TriumphOnline.Net Notice : New *RECALL* Service Bulletins No. 357 - 366

**NEW *RECALL* SERVICE
 BULLETINS NUMBERS 357 - 366**

Recall Action Notice Service Bulletin 357

Affected Models **Speed Triple (1050cc)**
VIN Range **Up to and including VIN 232290**
Markets **All**
Subject **1. Oil pressure switch connector and lead**
2. Ignition switch sub-harness security
2a. Ignition switch sub harness fly lead
3. Engine breather hose security
4. Coolant bypass hose replacement

1. Oil pressure switch connector and lead

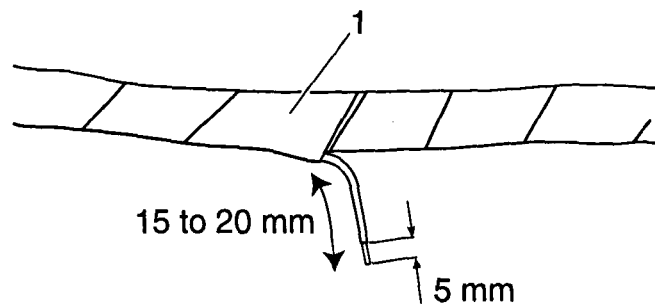
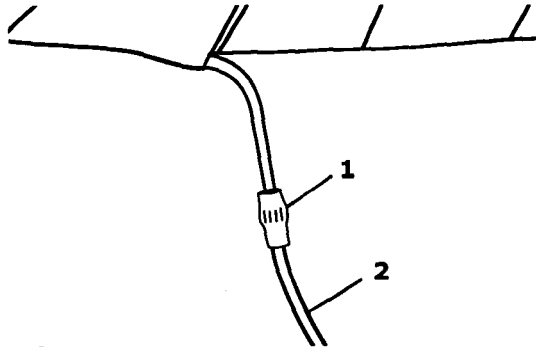
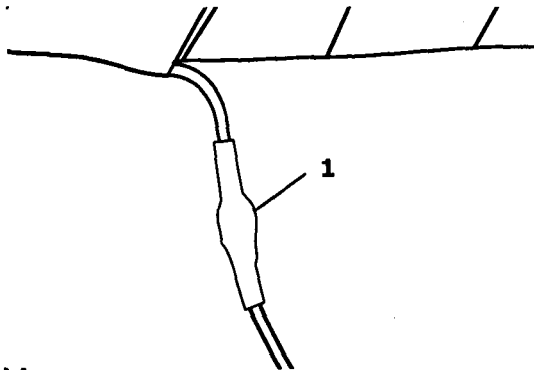
- 1. Oil pressure switch connector and lead** - Speed Triple motorcycles within the above VIN range were fitted with an incorrect oil pressure switch connector. Dealers are required to replace this connector following the procedure listed in part 1 of this bulletin.

4. Cut the oil pressure switch wiring approximately 15 to 20 mm from where it joins the main wiring harness, discard the connector and length of wire. Strip approximately 5 mm of sheathing from the remaining end attached to the main harness (see below).

6. Join the wiring prepared in step 4 to the new oil pressure switch fly lead using the crimping connector supplied. Ensure the joint is secure.

7. Slide the heat shrink tubing over the joint and, using a heat gun, shrink the tubing around the joint.

2. Ignition switch sub-harness security

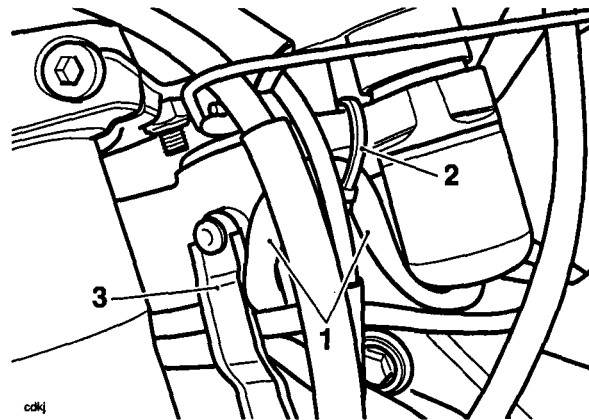
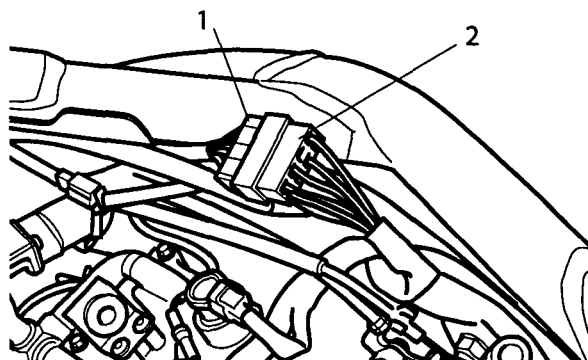
- 2. Ignition switch sub-harness security** - In order to prevent the sub-harness for the ignition switch from rubbing against the front subframe, dealers are required to secure the sub-harness to the ignition switch body following the procedure listed in part 2 of this bulletin.

1. Turn the steering to full right-hand lock to gain access to the sub-harness for the ignition switch.
2. Secure the sub-harness to the body of the ignition barrel as shown using 1 off cable tie (T3700015).

3. Ensure that sufficient harness is pulled through the right-hand harness guide to allow the steering to move freely from left to right full lock.

2a. Ignition switch sub-harness fly lead

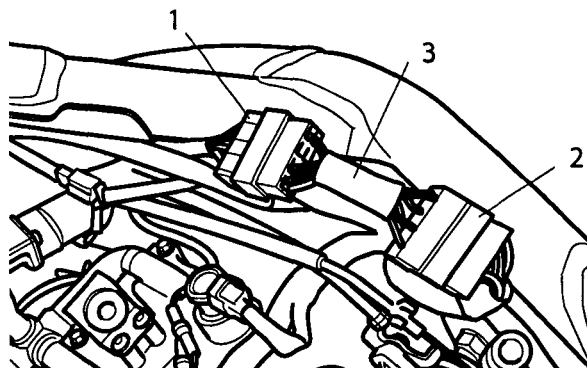
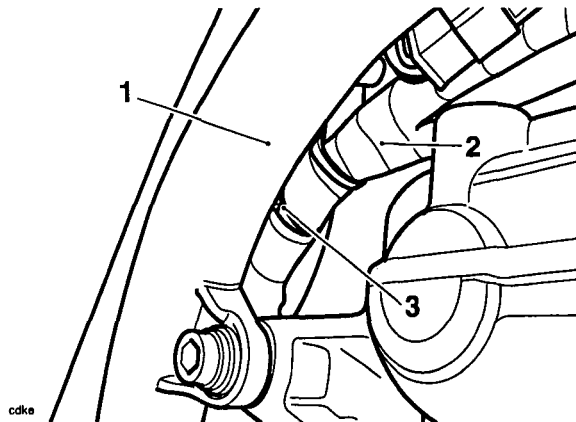
- 2a. Ignition switch sub-harness fly lead** - In some instances, the sub-harness for the ignition switch will be too short to be secured correctly. In these cases, dealers are required to extend the length of the sub-harness by fitting a fly lead following the procedure listed in part 2a of this bulletin.

3. Connect the fly lead (T2501595) in between the sub-harness connector and the main wiring harness connector as shown.

4. Ensure that the wiring does not interfere with the correct operation of the throttle mechanism.

3. Engine breather hose security

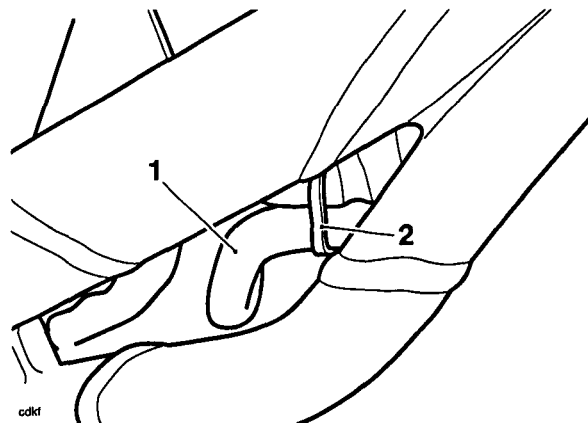
- 3. Engine breather hose security** - In order to prevent the engine breather hose contacting the throttle mechanism, dealers are required to secure the breather hose to the main wiring harness following the procedure listed in part 3 of this bulletin.

2. Secure the engine breather hose to the main electrical harness using 1 off cable tie (T3700015) in the position shown below. Do not over-tighten the cable tie.

3. Cut the cable tie so that the trimmed end is no longer than 10 mm. Rotate the tie so that the trimmed end does not catch or rub against any part of the motorcycle.
4. Before refitting the airbox (if removed), bodywork and fuel tank, carry out the additional work described in this bulletin.

4. Coolant bypass hose replacement

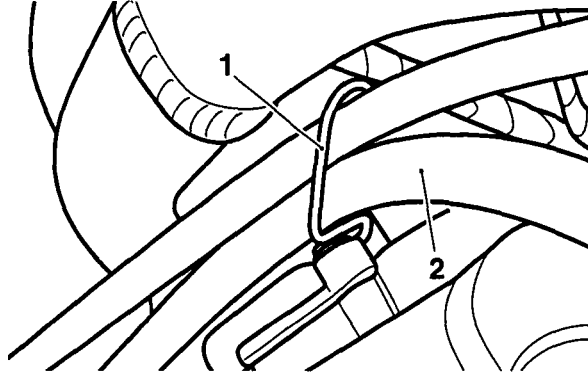
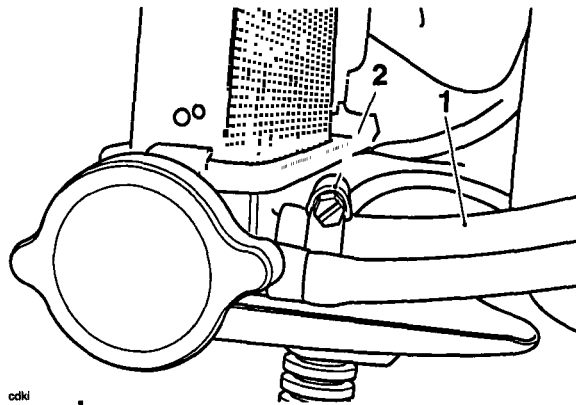
- 4. Coolant bypass hose** - The coolant bypass hose fitted to Speed Triple motorcycles within the above VIN range was manufactured incorrectly. Dealers are required to replace the bypass hose following the procedure listed in part 4 of this bulletin.

3. Pull the old bypass hose free from the engine outlet and quickly slide one end of the new hose in its place.
4. Examine the original hose clip for damage and, if serviceable, reuse. If the hose clip is damaged, replace the clip with a new one.
5. Slide the hose clip over the free end of the new bypass hose and use it to secure the hose to the engine outlet.

7. Pass the new bypass hose through the wire guide at the top of the engine as shown.

9. Examine the original hose clip for damage and, if serviceable, reuse. If the hose clip is damaged, replace the clip with a new one.
10. Slide the hose clip over the free end of the new hose, push the hose into position over the radiator spigot and secure with the hose clip.
11. Check/top up the coolant level as described in the service manual.
12. Refit the airbox (if removed), fuel tank and rear bodywork as described in the service manual.
13. Reconnect the battery, positive (red) lead first.
14. Refit the seat.
15. Start the engine and check that the low oil pressure warning light illuminates when the ignition is switched on and goes out shortly after the engine has started.
16. Check for coolant leaks. Rectify as necessary.

1. Rear brake hose
2. 'P' clip (T3700092)
3. Screw, M6 (3330030-T0301)

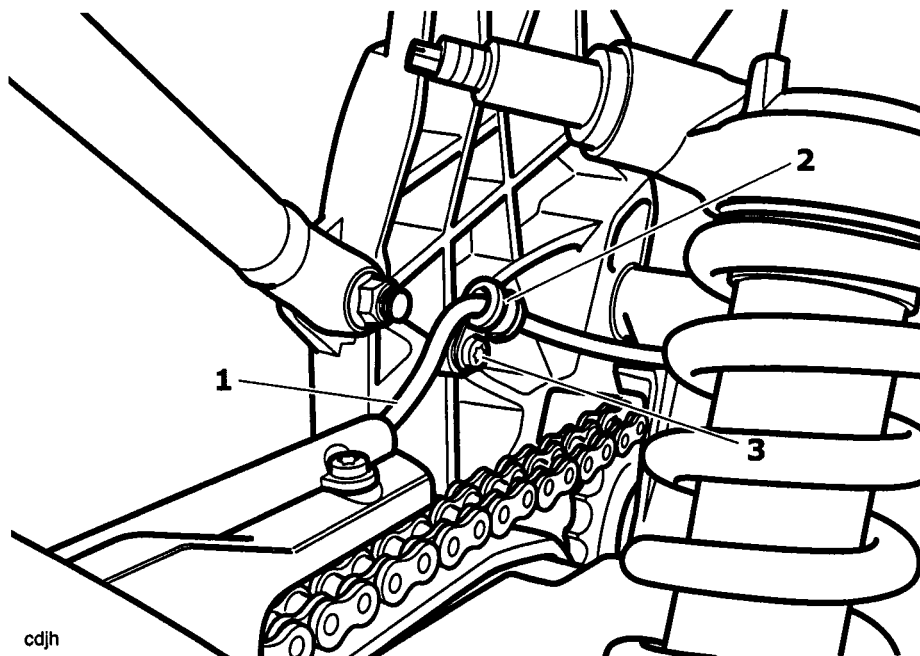
Certain SPRINT ST's also require the introduction of a P' clip to the rear brake hose.

- It is not necessary to remove the rear brake hose to fit the 'P' clip.
